DESIGN ADVISORY BOARD Tuesday, September 8, 2015 at 3:00 PM Conference Room 12, City Hall, Burlington, VT Amended Agenda

TO: Design Advisory Board
FROM: Scott Gustin
DATE: September 8, 2015
RE: 16-0209CA, 3174 North Avenue

To: The Design Advisory Board
From: Mary O'Neil, AICP, Senior Planner
RE: ZP16-0263CA; 584 South Prospect Street
Date: September 8, 2015

PROPOSED CONDITIONS SITE PLAN
HARDACRE REAL ESTATE HOLDING, LLC

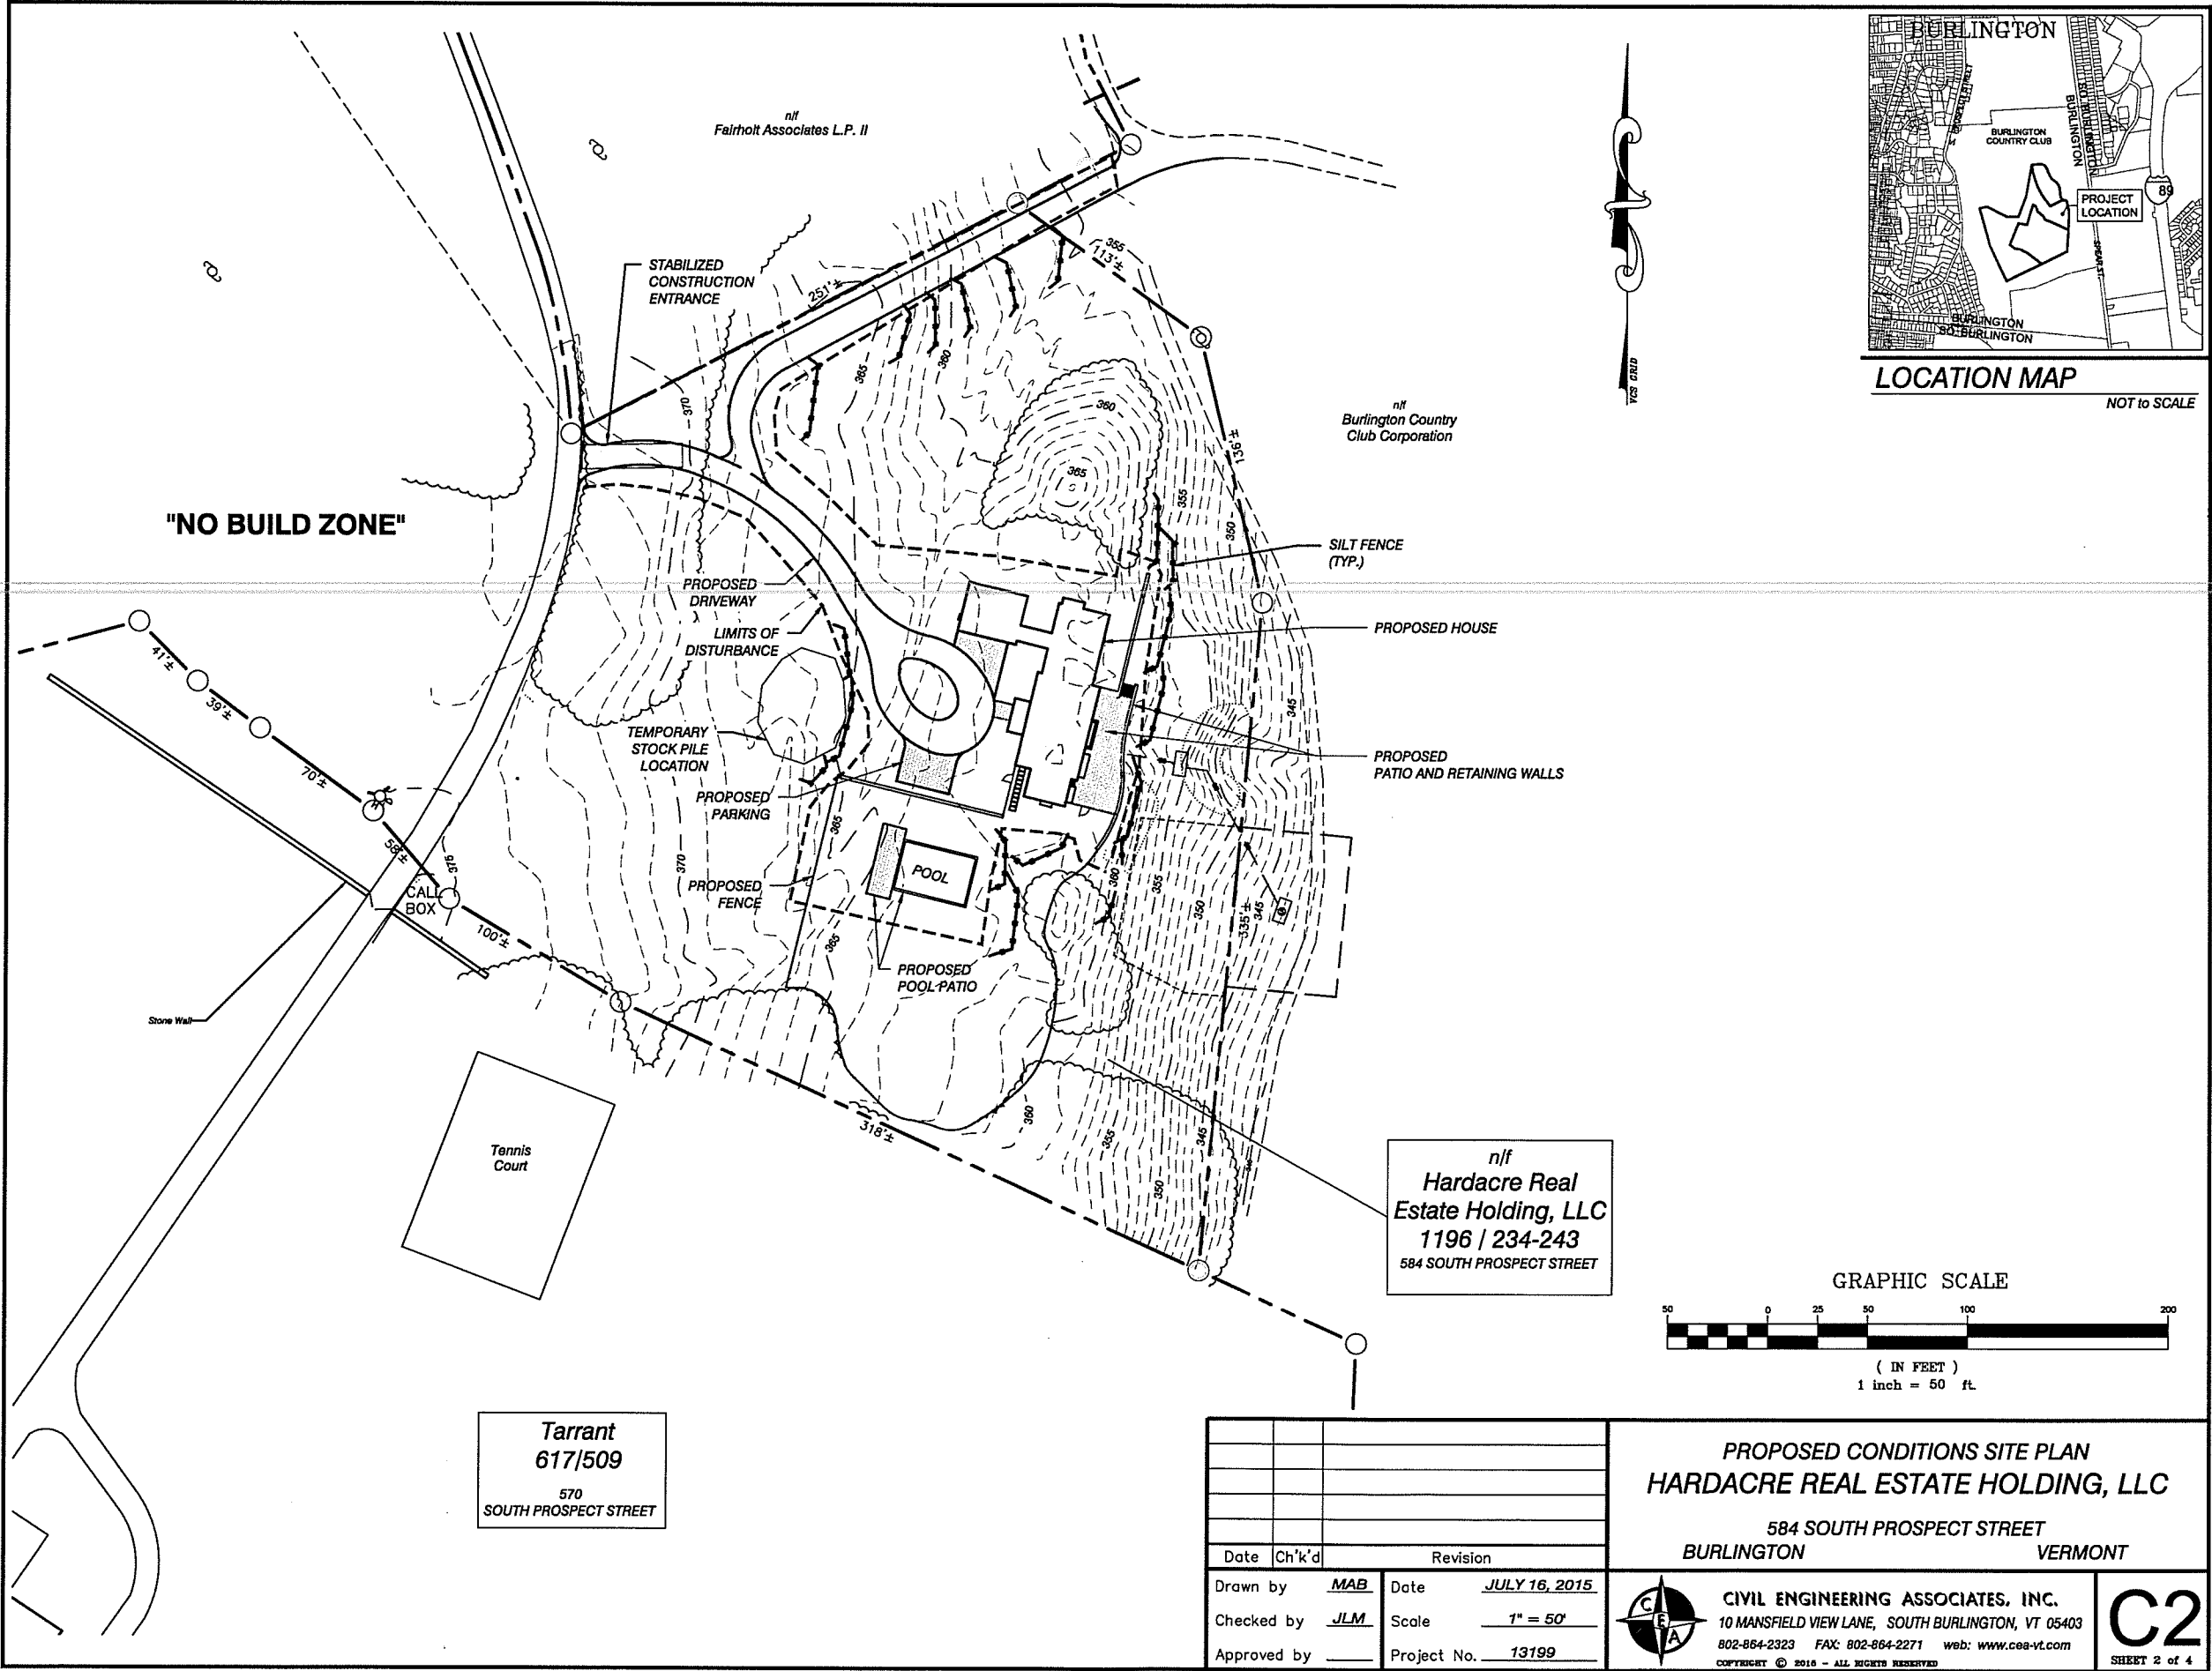
A landscape plan has been provided (L1.0), although it does not define tree removal or the species/caliper of new plantings. This information shall be required. (Tree removal may be permitted as part of development per Section 5.5.4; however adequate information needs to be supplied to confirm compliance with that standard.)

A dog fence is identified on the plans, as well as free standing dry laid stone retaining walls.

Any exceeding 3’ in height will require review and approval by the city engineer.

EXTERIOR
ELEVATIONS

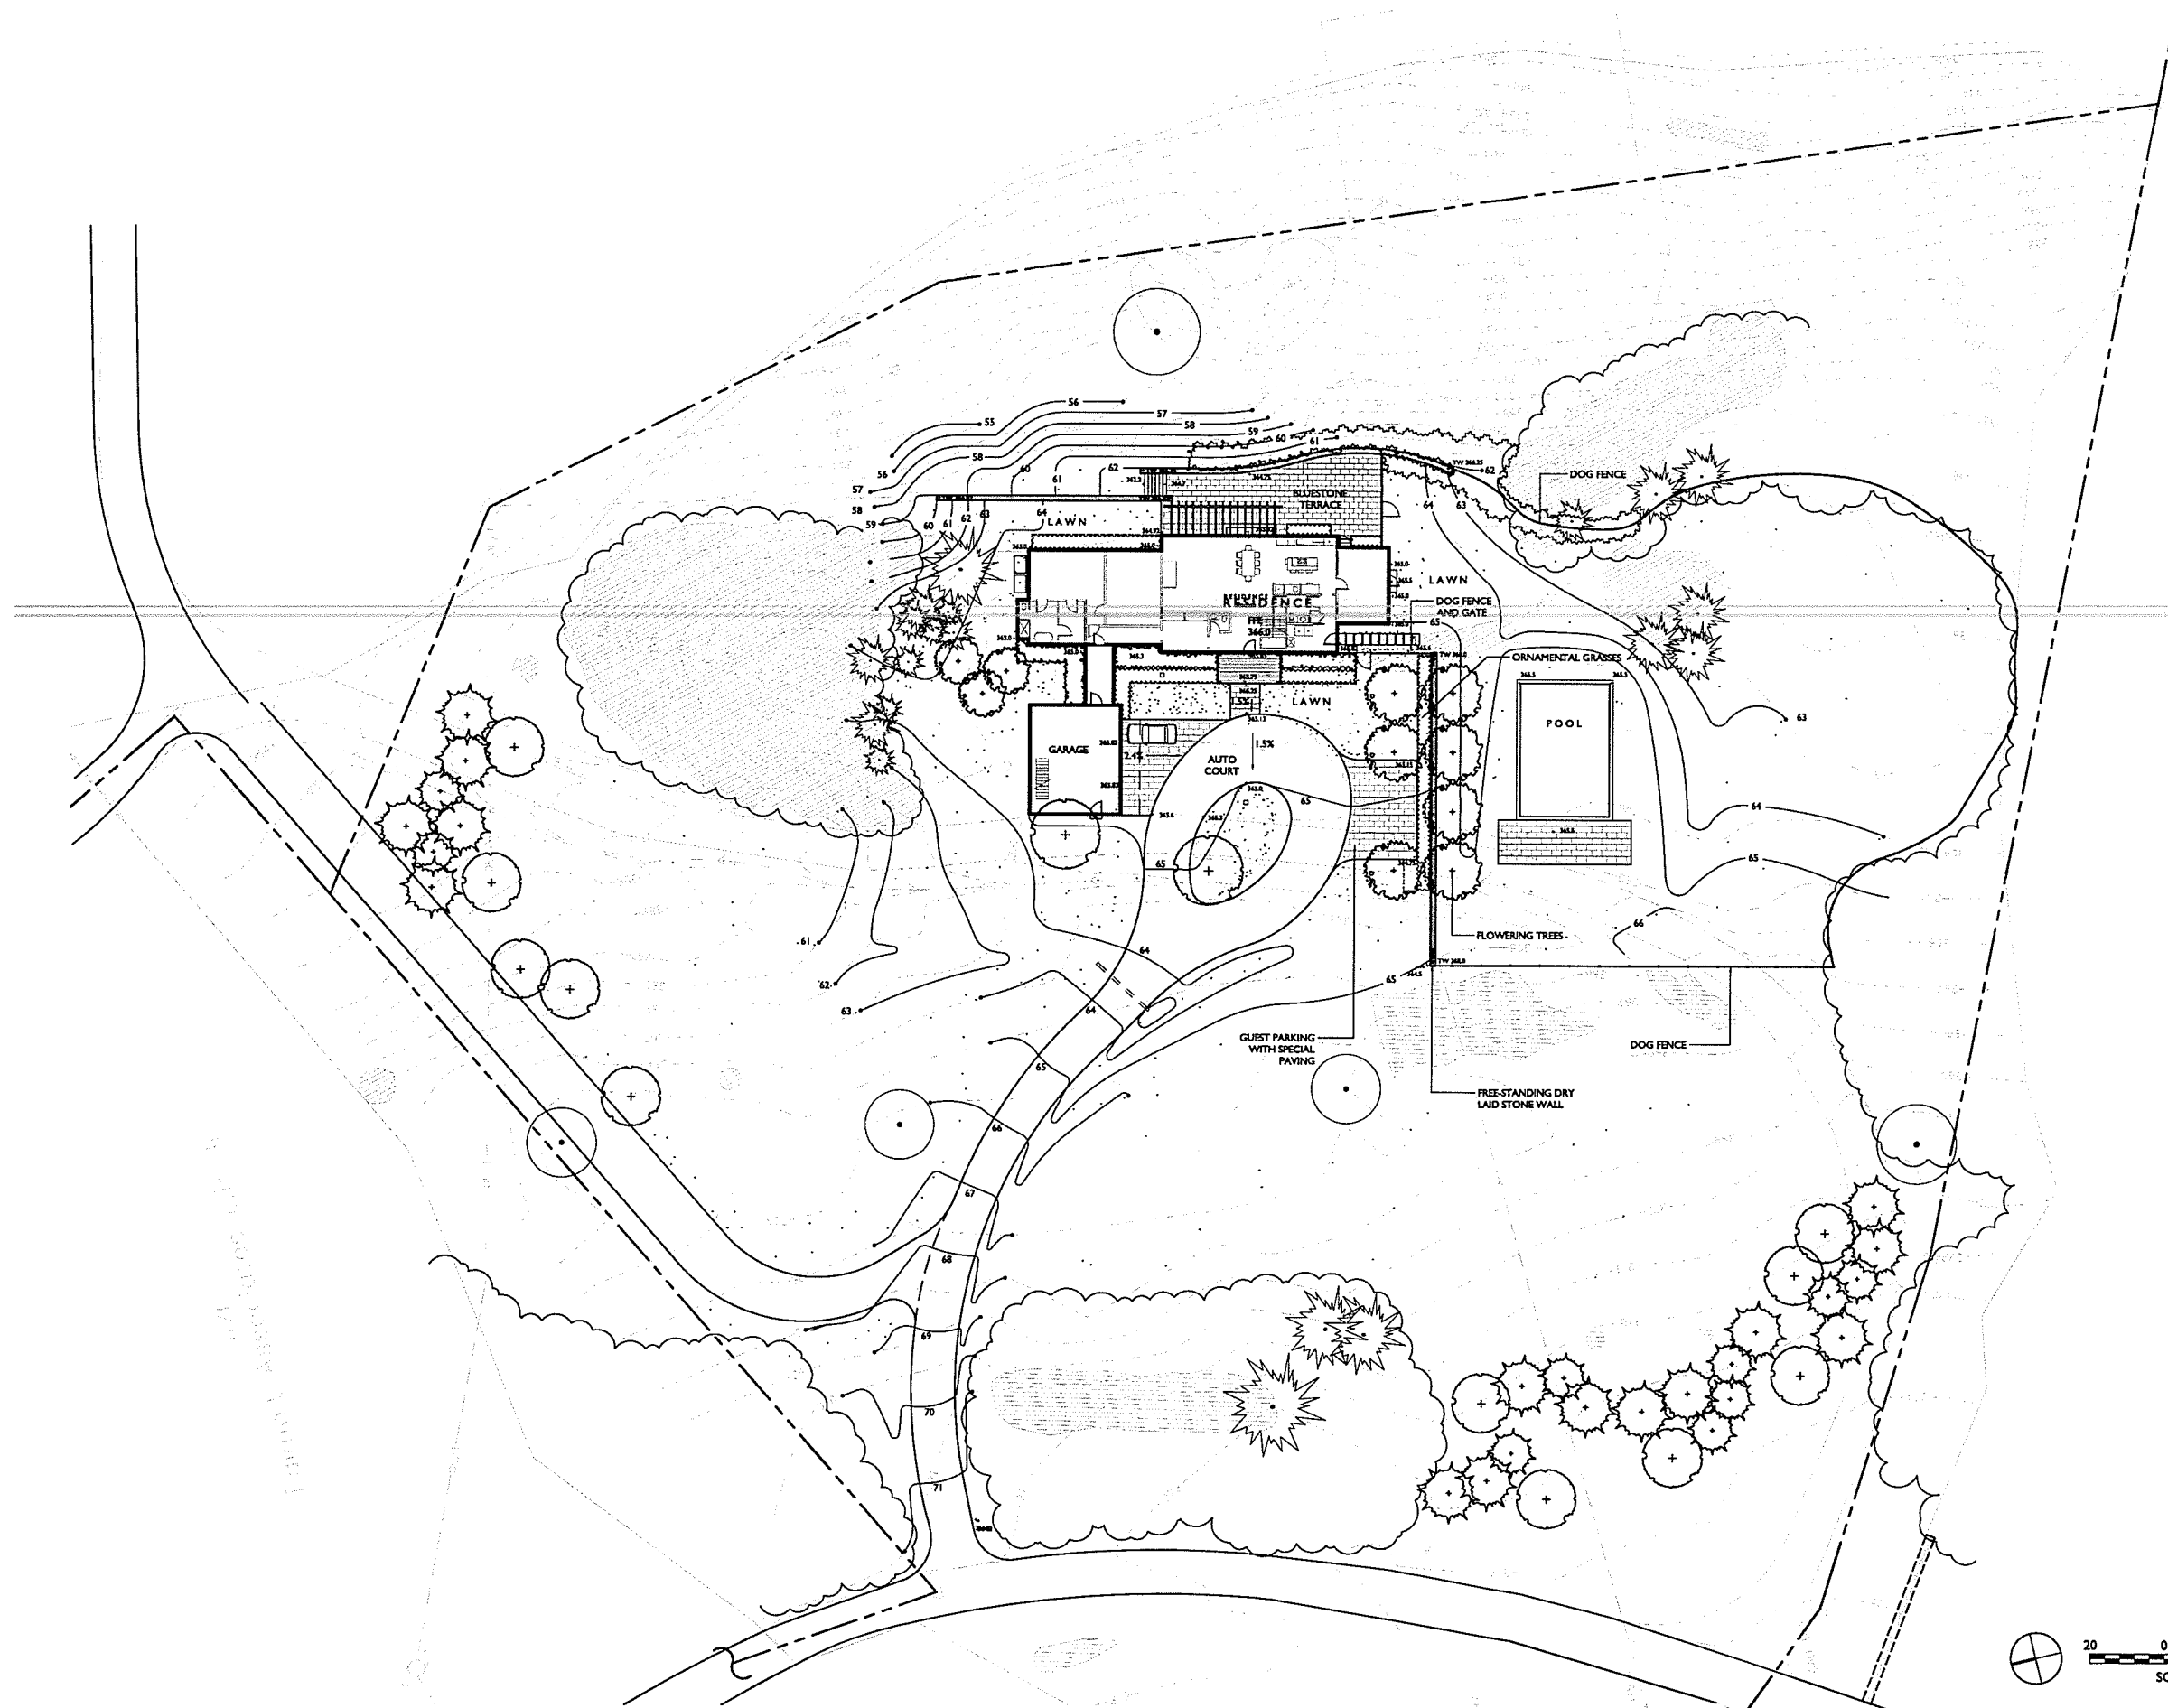
Ground mounted a/c mechanicals are proposed for the north elevation. As located on the north elevation and behind a small structural projection, additional screening does not appear to be necessary. Other utility connections are not evident on the plans, and need to be annotated on site and/or building elevations as appropriate.

Exterior finishes are proposed to be pre-stained eastern white cedar shingles with a 5” exposure; Marvin clad windows in stone white with mahogany trim, and a standing seam metal roof in “sage.” All are considered durable and likely to extend the life cycle of the building.
